SUNDRY NOTICES AND REPORTS ON WELLS

Pure Gold Federal #9

Pure Gold D Federal #9
API No. 30-015-35798

**Pure Gold D Federal 9
OXY USA Inc.
November 14, 2011
Conditions of Approval**

OXY USA Inc.
Pure Gold D Federal #9
API No. 30-015-35798

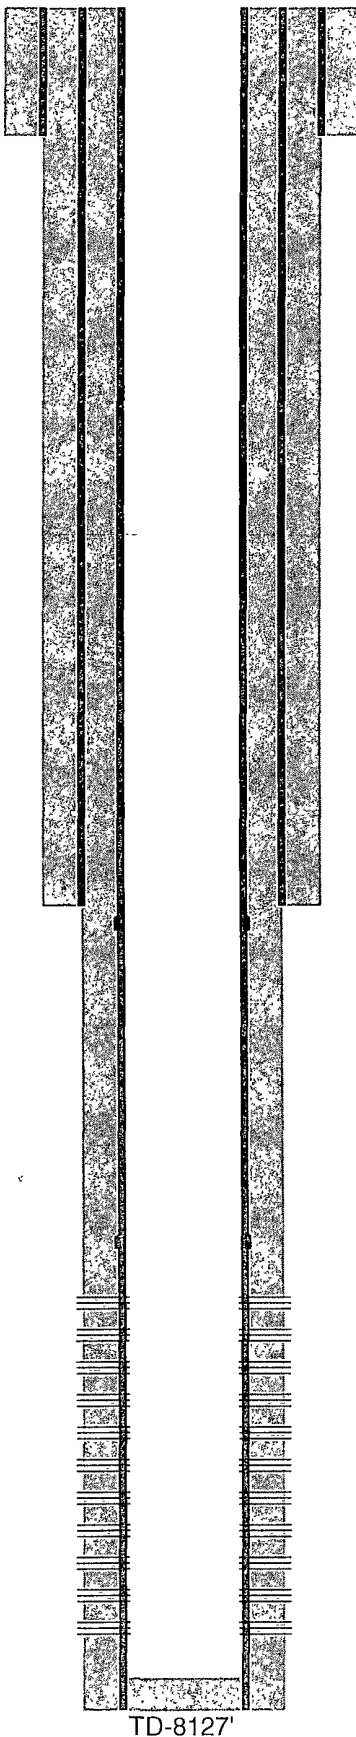
- 4. A minimum of a 3000 (3M) BOP to be used. All blowout preventer (BOP) and related equipment (BOPE) shall comply with reasonable well control requirements. A two ram system with a blind ram and a pipe ram designed for the size of the work string shall be adequate. Tapered work strings will require an additional pipe ram. The manifold shall comply with Onshore Oil and Gas Order #2 Attachment I (3M Diagrams of Choke Manifold Equipment). The accumulator system shall have an immediately available power source to close the rams and retain 200 psi above pre-charge. The pre-charge test shall follow requirements in Onshore Order #2.**

- 6. Operator limited to 3700 psi on the frac down the casing. This is based on 70% of the 5.5" 17# J-55 casing's burst rating.**
- 7. Operator to submit a subsequent sundry with details of work performed including a new well test. Due to classification as one pool under order R-10086, no completion report is required.**
